#3023870

8311 15th Ave NW
RECOMMENDATION MEETING
NORTHWEST DESIGN REVIEW BOARD
November 20th 2017

RESPONSE TO EARLY DESIGN GUIDANCE

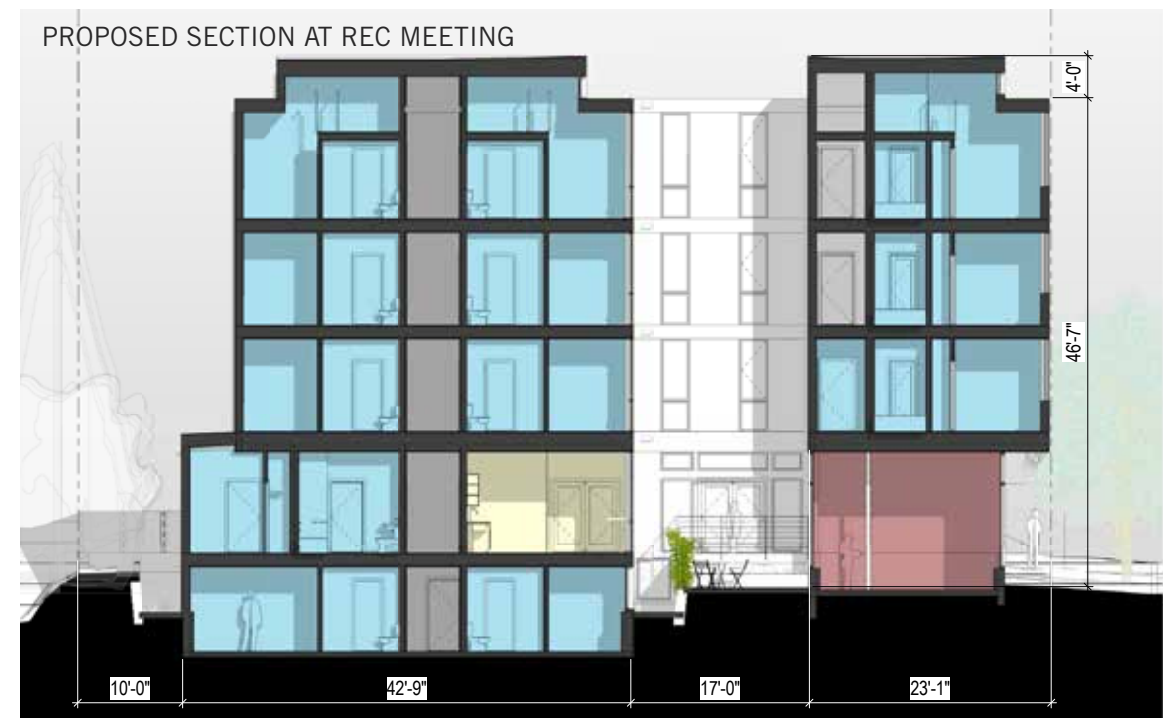
a. Further reconcile the relationship of the basement units to the courtyard space. Clarify how both light and privacy will be accommodated. (CS1-B-2)

Light and privacy for these units will be provided by a grade change and privacy plantings (Evergreen Clematis). Please see opposite page for courtyard section and accompanying text, as well as landscape plan on p. 52.

PROPOSED ENTRY PLAN

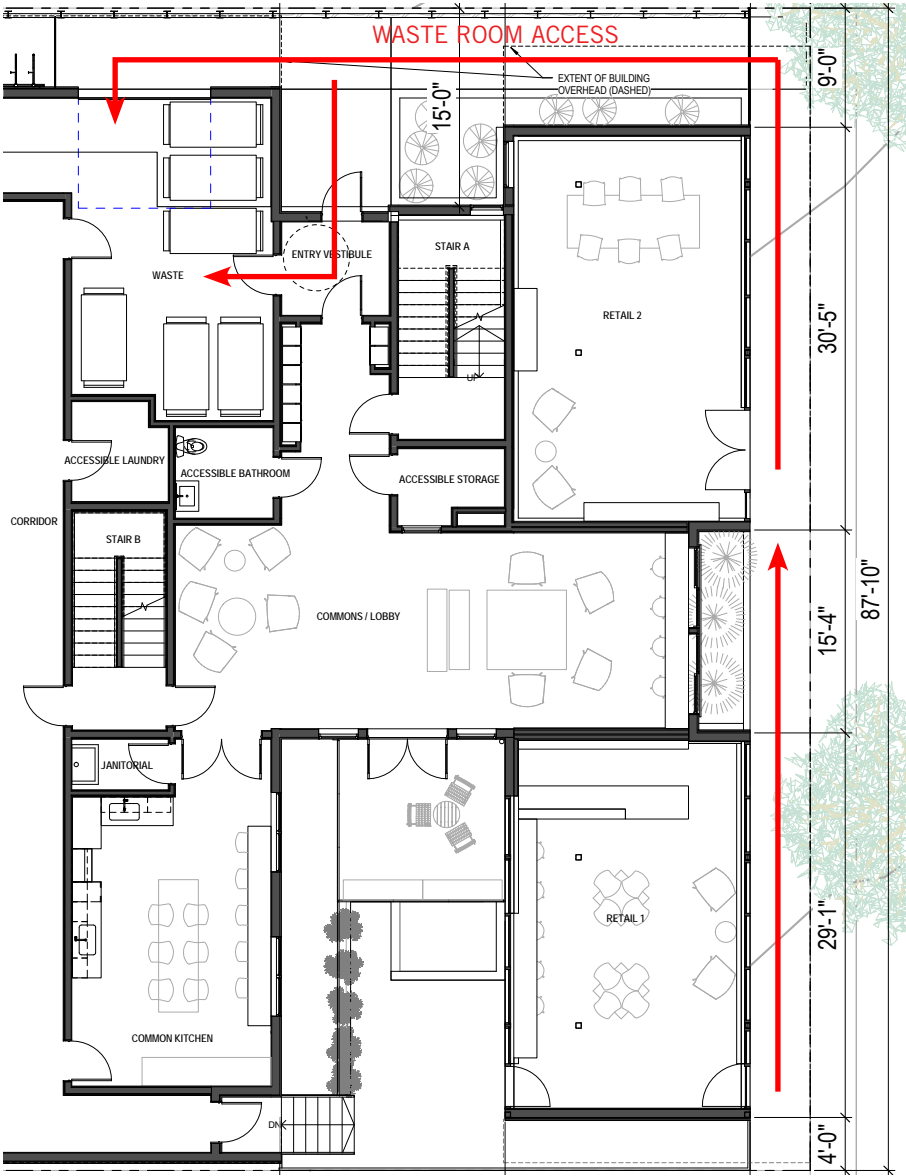
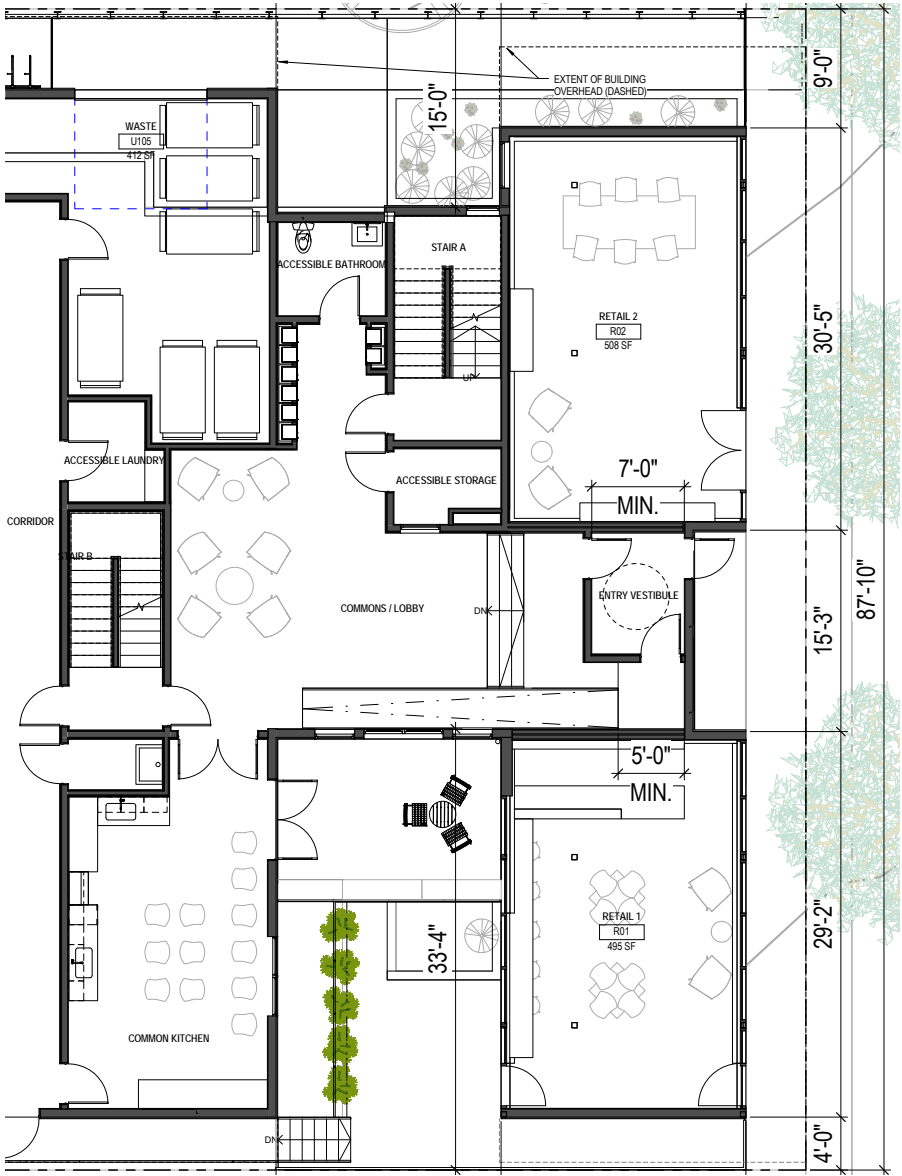
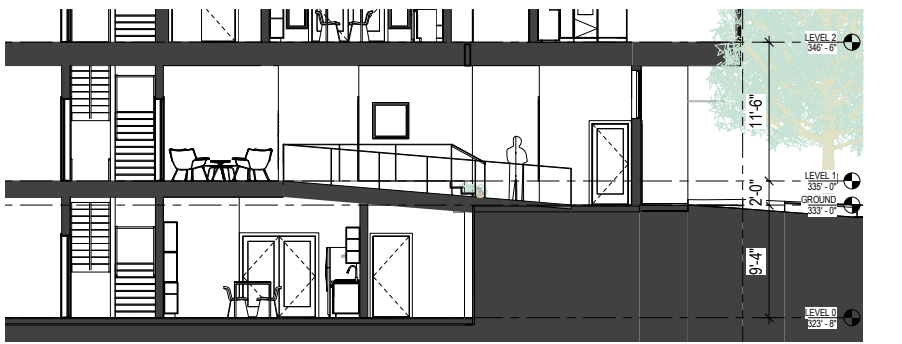
b. The Board discussed the proposed entry location, commenting the lobby area along the street front was an interesting concept and response to activating the street frontage rather than the standard pass-through entry lobby. However, the Board would like to see further analysis of the proposed entry location (along the north edge) as the best solution. (CS2-C-2; CS2-B-2)

DESIGN RESPONSE: Please see plans and sections (opposite page, far right) for comparison between proposed lobby and the pass-through alternative. Change in grade across the site (alternate lobby entrance is 2' lower than proposed) necessitates either an accessible ramp that compromises connectivity and functionality, or lowering the height of Level 1, resulting in a lower basement level and reduced daylighting for those units.

- DISADVANTAGES OF ALTERNATIVE (PASS-THROUGH) ENTRY:**
- 1 — Less usable space at common area;
 - 2 — Less connection from common space to courtyard;
 - 3 — Eliminates natural light for basement units;
 - 4 — To remove the ramp in alternative entry design, the basement has to be 2' lower into the ground, which will reduce natural light for all units in basement;
 - 5 — Poor connection within the building to trash room.
